1 Products affected

2 Type of change

Product C	Product Change Notification						CQP improvement		
owner	creation date	release date	released by	change order no	rev	page	D40 000 007		
dislercy	2016-09-23	2017-01-06	nowakfr	2008865	Α	1 of 1	D10-008-987

3 Detailed description of change

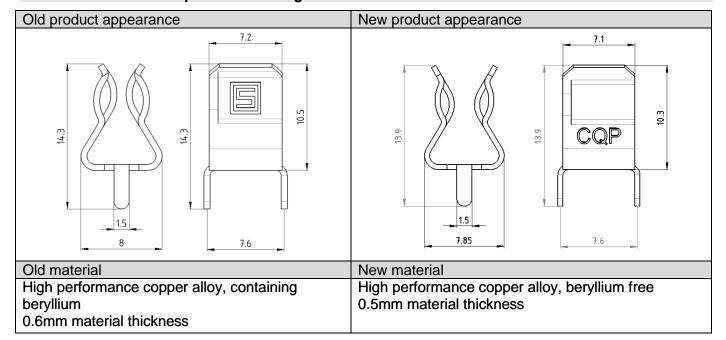
- Change of material
- Change of geometry

- The clip material was changed to a higher performance and higher electrical conductivity material to improve fuse insertion and withdrawal force.
- The higher performance copper alloy has three times higher specific conductivity than CuBe.

Form Yes Form, material and material thickness changed

Fit Yes Clip is slightly smaller

Function Yes Insertion and withdrawal force for 6.3mm diameter fuse to clip is lower
